Review of ORAUT-OTIB-0081, Revision 04, “Internal Coworker Dosimetry Data for the Savannah River Site ”

Bob Barton, Ron Buchanan,
Harry Chmelynski, Rose Gogliotti,
Joyce Lipzstein
SC&A, Inc.

Advisory Board on Radiation and Worker Health Meeting
December 11, 2019, Oakland, CA

Coworker Data Adequacy – Bioassay Variability

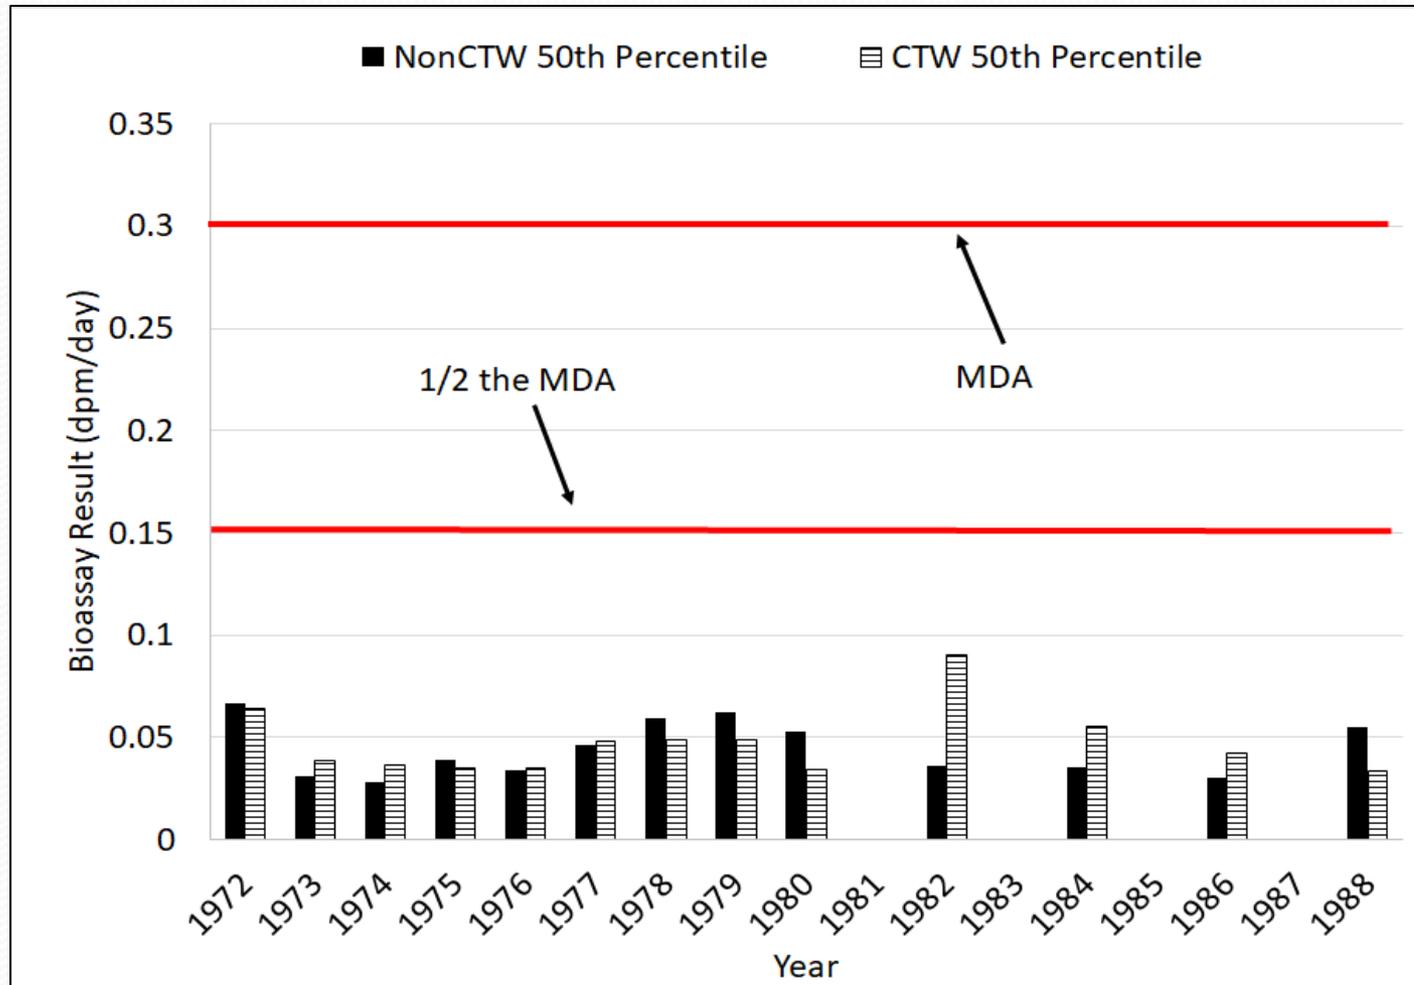
- SC&A has expressed concern about observed variability in transuranic (Am/Cm/Cf) measurements of the same bioassay sample in previous SRS reviews and work group discussions.
- **Key Question:** Is the measurement technique sufficiently accurate to reflect the exposure potential it is intended to quantify?
- **OTIB-0081 Concluded:**
 - Small percentage of the identified samples that are unaffected by chelation showed high variability (4 of 52)
 - “aliquot variability has an insignificant effect on the overall results”

Coworker Data Completeness – Percentage of Additional Claimant Data Available

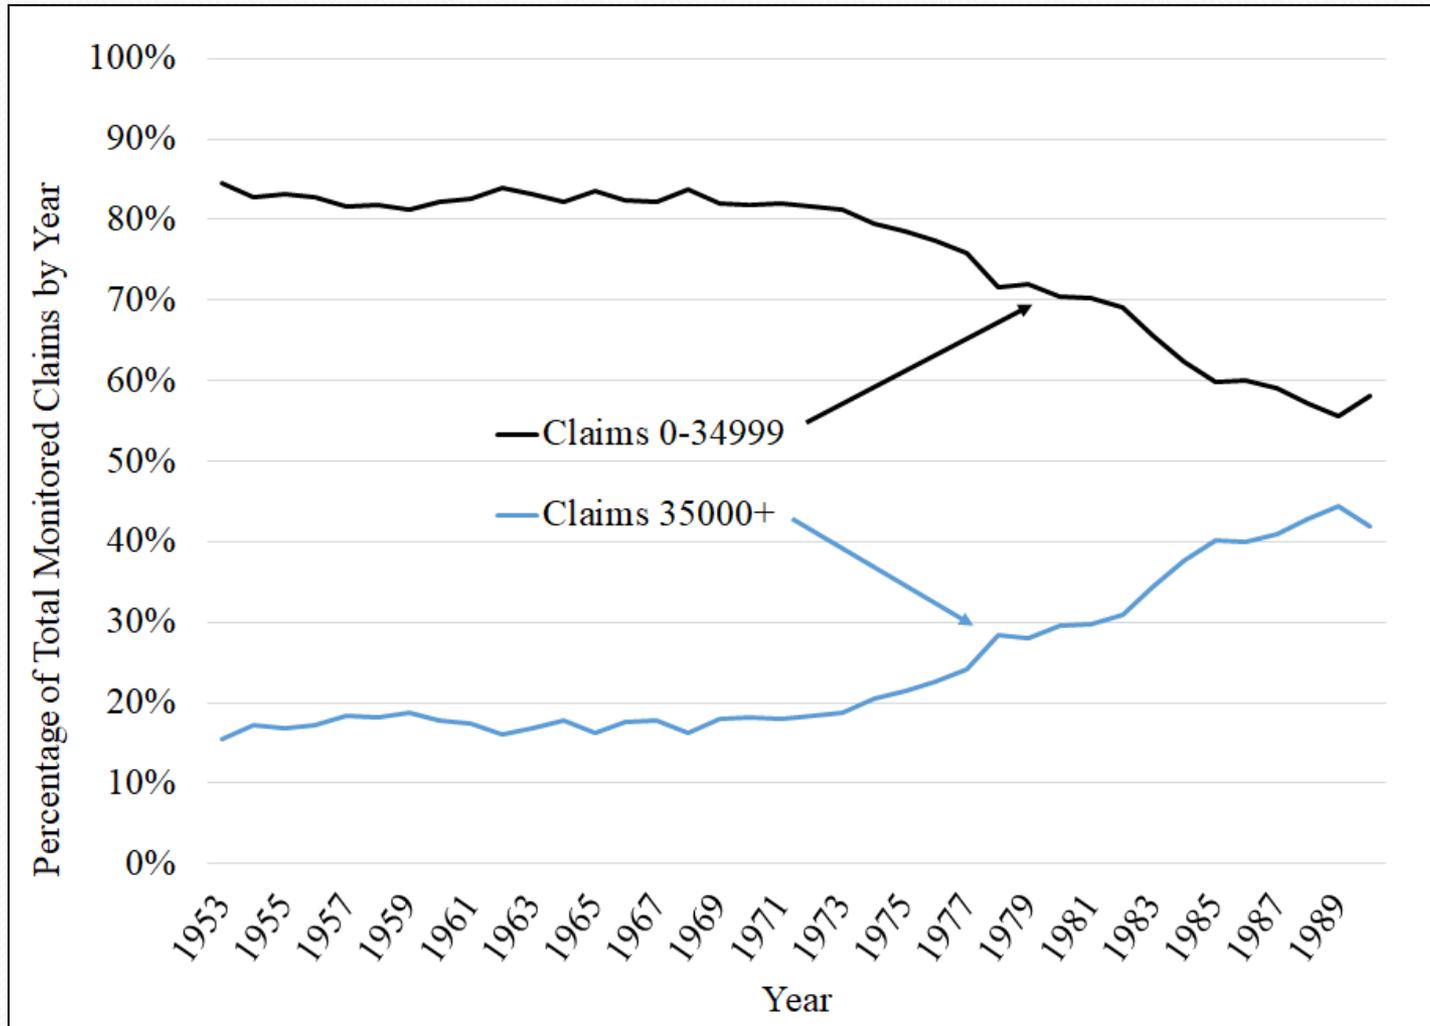
Finding 4: The coworker analysis uses the internal monitoring for claimants for which data were available to NIOSH in approximately August 2011 (~4,000 claims). Since that time, approximately 2,000 additional claims have been submitted that could be used to augment the coworker dataset. Inclusion of these data would be especially important for the two contaminants that required a combination of multiple years for analysis due to lack of a sufficient number of data points (uranium and cesium).

Coworker Data Completeness – Comparison of Reported Bioassay Totals to Bioassay Available for Analysis

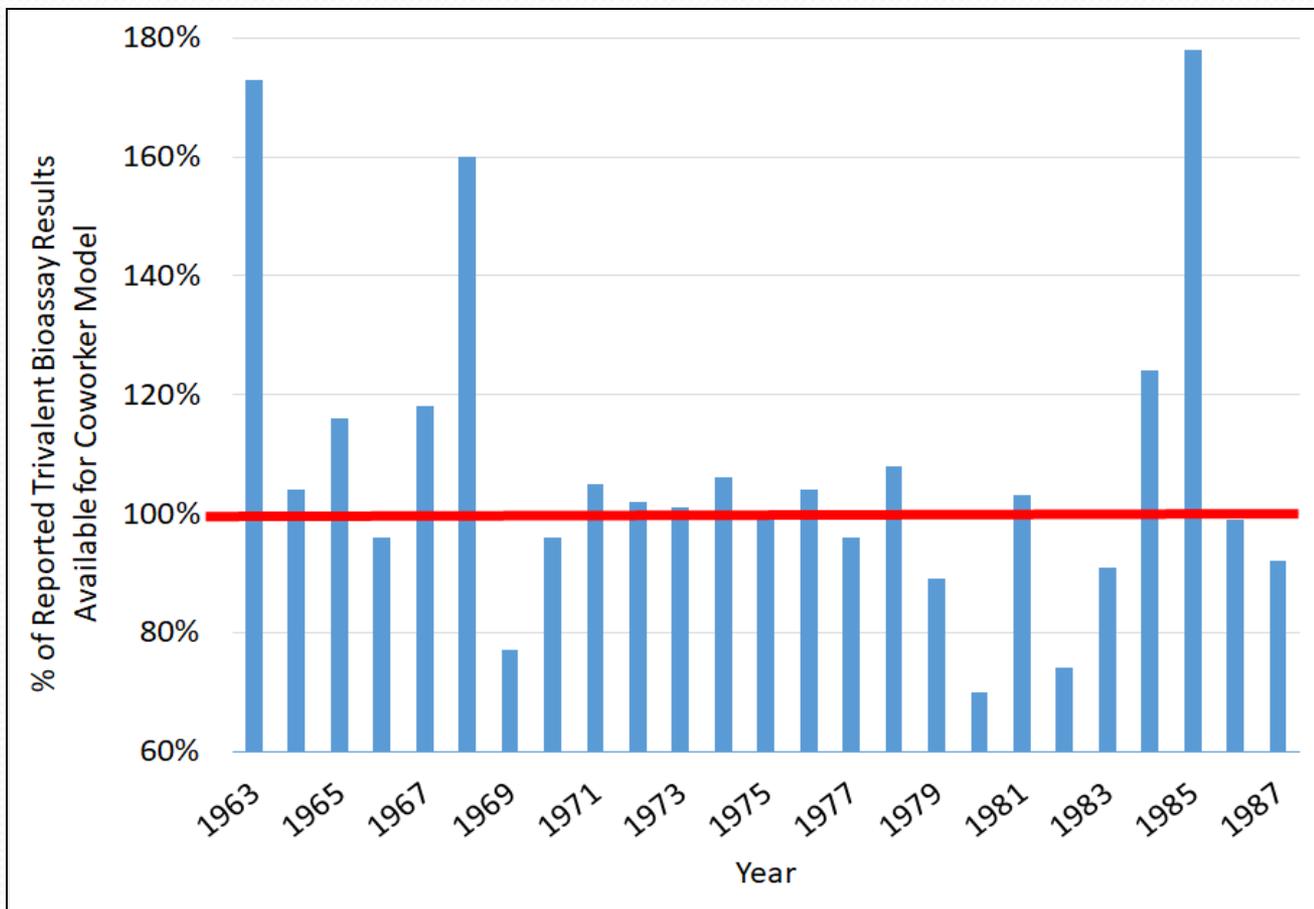
Observation 3: Available trivalent logbook data show notable differences with the number of reported samples taken in 1980 and 1982. These years, and any changes in operations, are not discussed specifically in OTIB-0081. However, it is noted that a future NIOSH report on americium exposure potential at SRS is pending that may address the apparent gaps in the data.

- **UPDATE:** NIOSH has since released ORAUT-RPRT-0091, “Evaluation of Savannah River Site Americium-241 Source Terms Between 1971 and 1999 Using Bioassay Frequency Tables.” However, the report does not specifically address the issue of missing Am/Cm/Cf bioassay results during the years identified.
